**Hamburg Township
Zoning Board of Appeals
Hamburg Township Board Room
Wednesday, August 12, 2020**

Zoning Board of Appeals Staff Report

SUBJECT: ZBA 20-008

PROJECT 10910 Bob White Beach
SITE: Boulevard
TID 15-27-401-037

example method #2 – physical wetland barrier

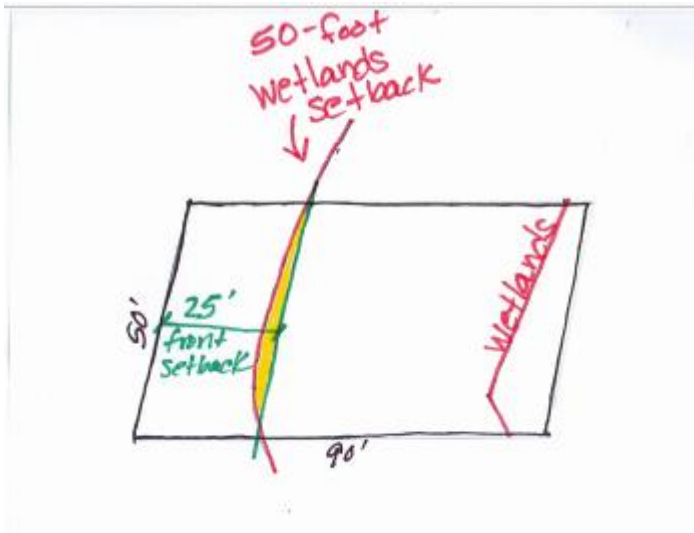
The ZBA could request a property owner protect the wetlands with one of the following methods -.

1. The homeowner could submit an engineered drainage plan for the property, prepared either by a civil engineer or registered landscape architect that would ensure runoff from the garage does not drain into the wetlands.
2. The homeowner could construct a physical barrier along the wetlands to preserve the wetland from further encroachment by lawn equipment or any other trampling of the area.
3. The homeowner could record an open space or wetland easement over the wetland portion of the site to restrict development and interference with the natural vegetation of the area in the future.

1. An engineered drainage plan, prepared either by a civil engineer or registered landscape architect, for the property that would ensure runoff from the accessory structure does not drain into the wetlands.
2. Construct a physical barrier along the wetlands to preserve the wetland from further encroachment by lawn equipment or any other trampling of the area.
3. Record an open space or wetland easement over the wetland portion of the site to restrict development and interference with the natural vegetation of the area in the future.
4. The accessory structure size shall be reduced to further reduce the encroachment into the wetlands setback, allowing for a setback determined by the ZBA at the August 12, 2020 hearing.

SITE PLAN

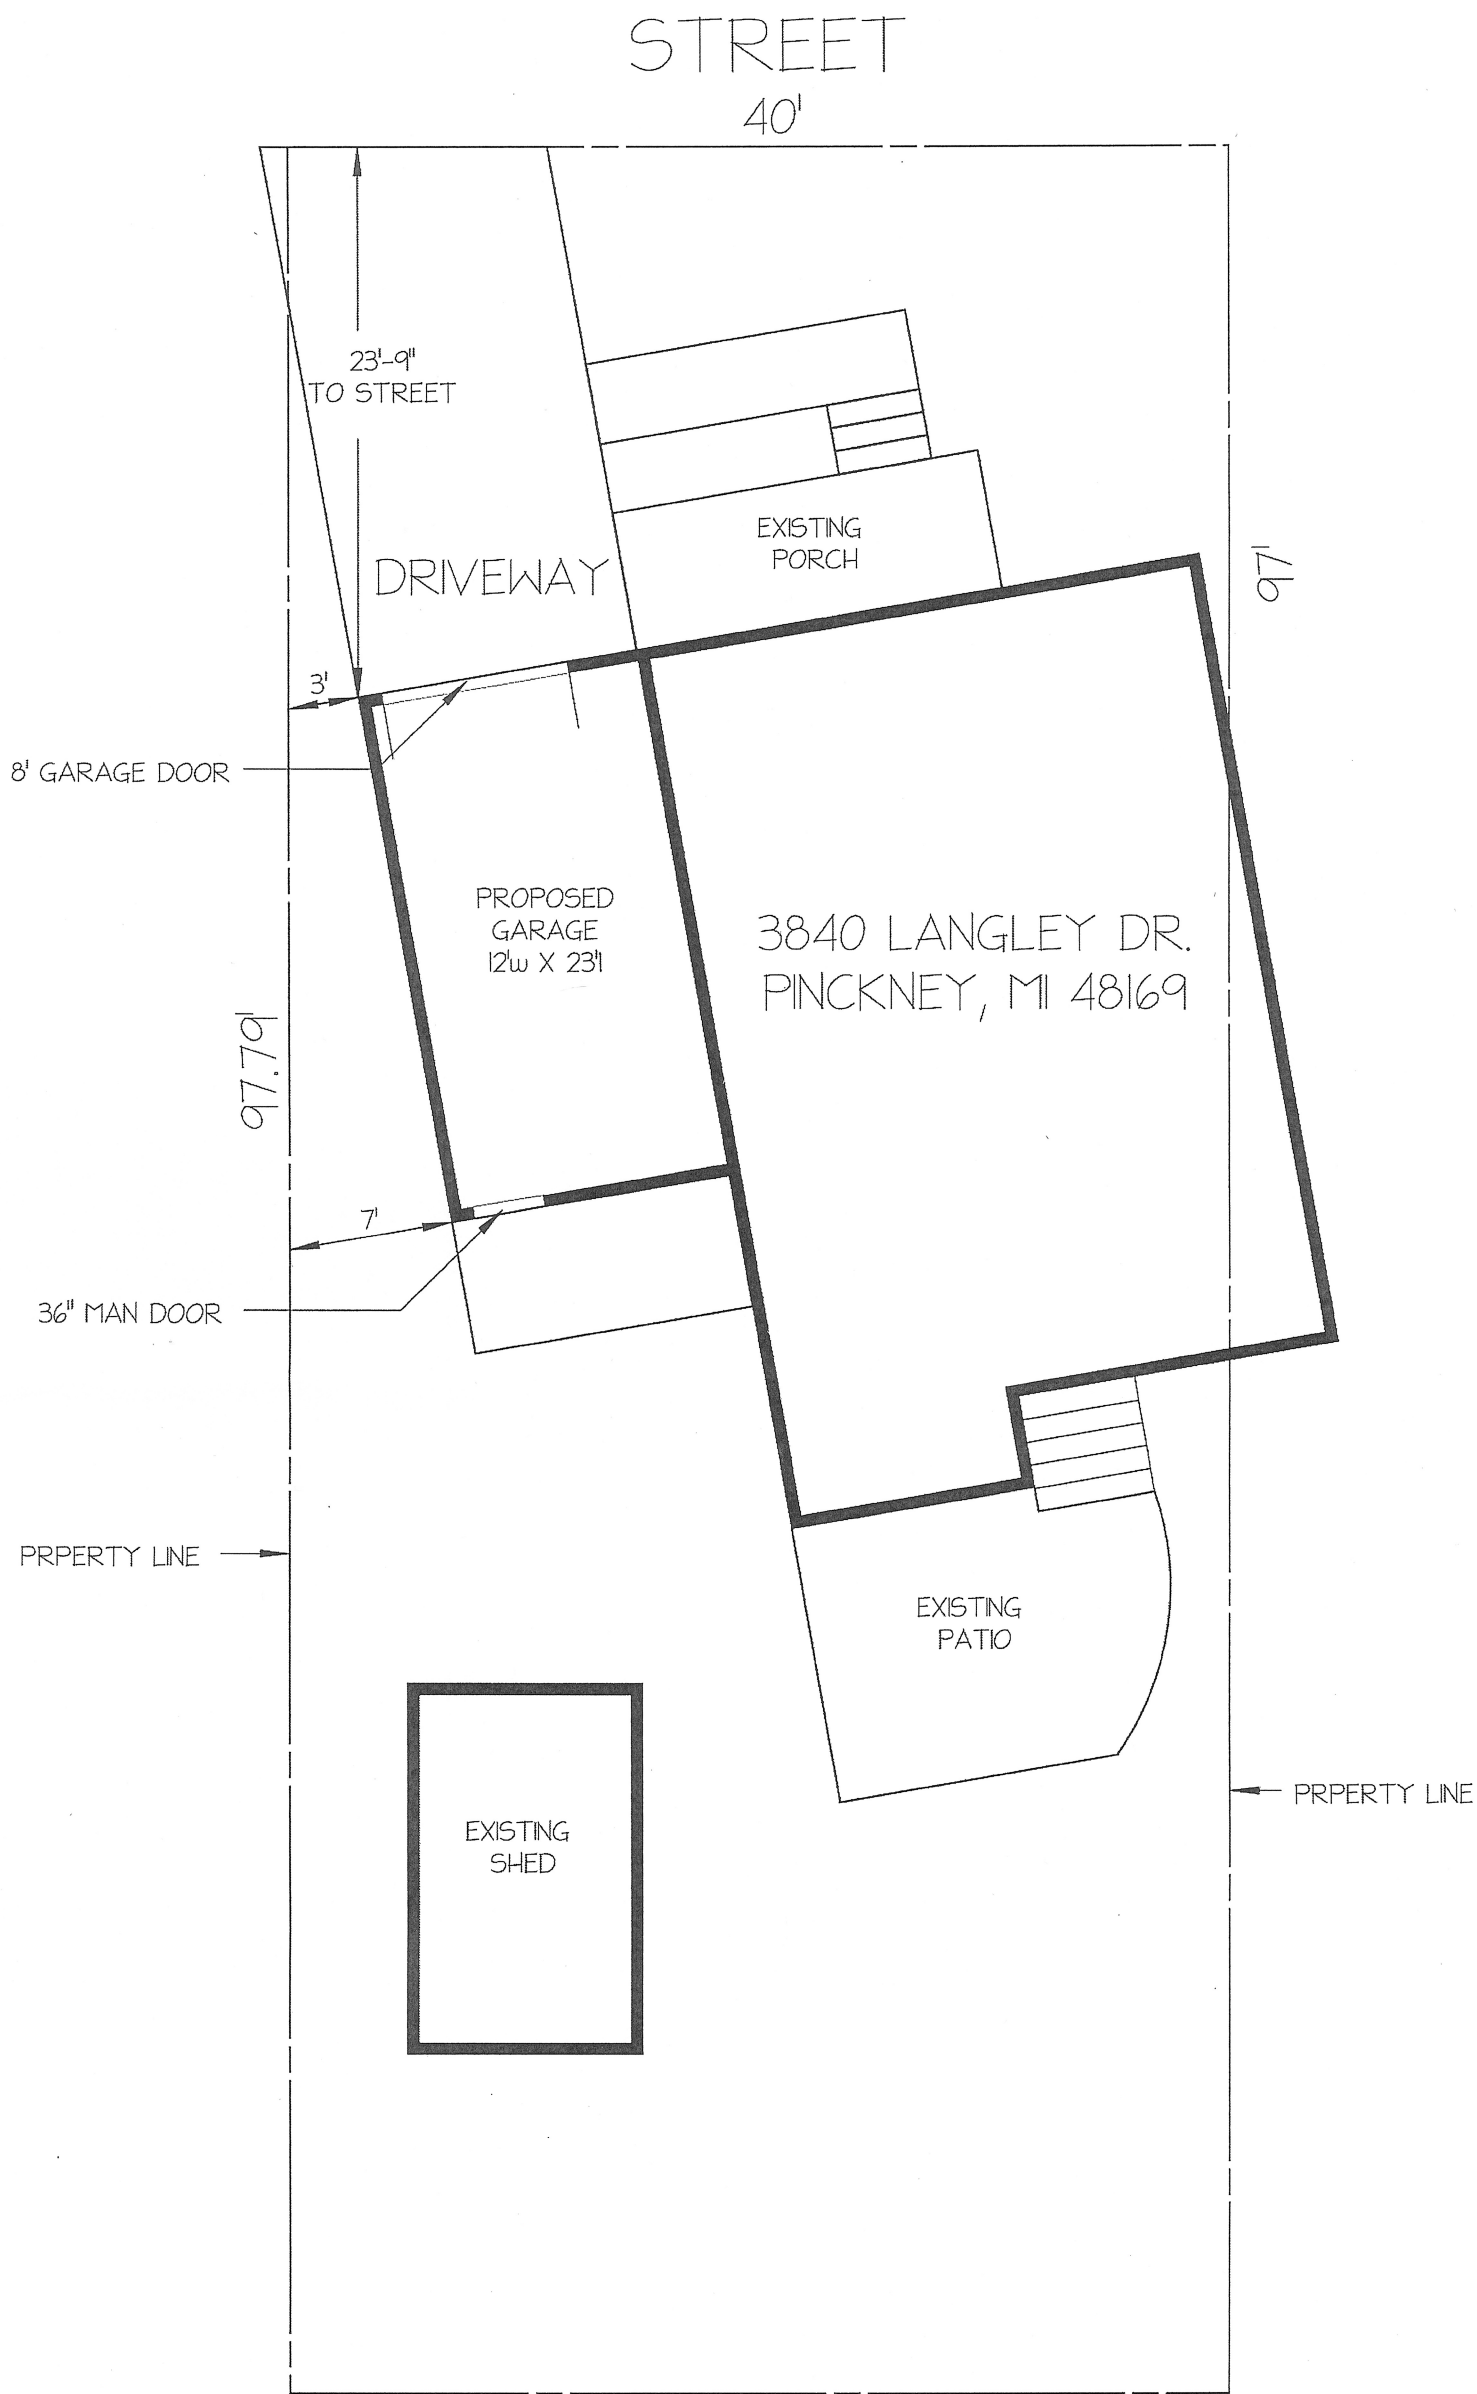
Request: Variance application to permit the addition of a twelve-foot by twenty-three-foot attached accessory structure to the west facade of the existing dwelling, with up to a three-foot aggregate side yard setback (fifteen-foot aggregate side yard setback required, Section 7.6.1.fn4).
